• SUSPENSION—GRUNTING/POPPING NOISE FROM THE FRONT SUSPENSION WHEN TURNING • NOISE—GRUNTING/POPPING NOISE FROM THE FRONT SUSPENSION WHEN TURNING	Article No. 02-13-2

FORD: 1995-2002 WINDSTAR

Figure 1 - Article 02-13-2

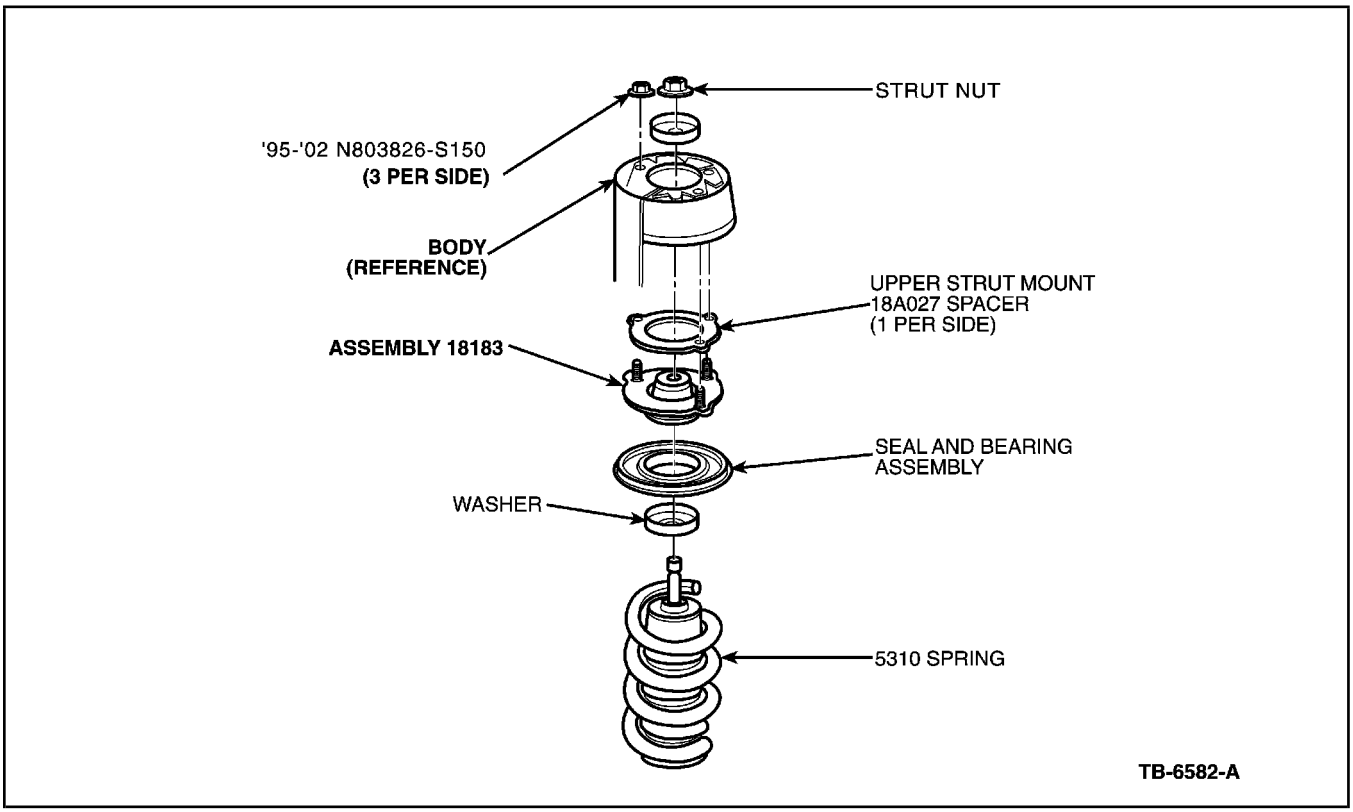
Some vehicles may exhibit a grunt/popping noise coming from the front suspension at speeds below 20 MPH (32 KM/H) when turning. This may be caused by contact between the rubber coated outer rim of the upper spring seat bearing and seal assembly at the underside of the shock tower sheet metal. Colder weather could result in this rubbing noise being more noticeable.

Install 2F2Z-18A027-BA spacers between the front strut assembly mounting bracket and the strut tower. Refer to the following Service Procedure for details.

1. Park the vehicle on a level surface.
2. Remove both front strut assemblies as detailed in the Workshop Manual Section 04-01.
3. Inspect the strut assemblies to make sure that all components are properly fitted together, especially the upper spring seat/bearing/seal and the upper strut mount.
4. Place the upper strut mount spacer (18A027) over the three mount studs prior to reinstalling the strut assembly so the spacer is positioned between the underside of the shock tower and the upper strut mount. This procedure must be performed on the right and left strut assemblies. Refer to Figure 1.
5. Reinstall the front strut assemblies with spacer according to the applicable Workshop Manual Section 04-01.
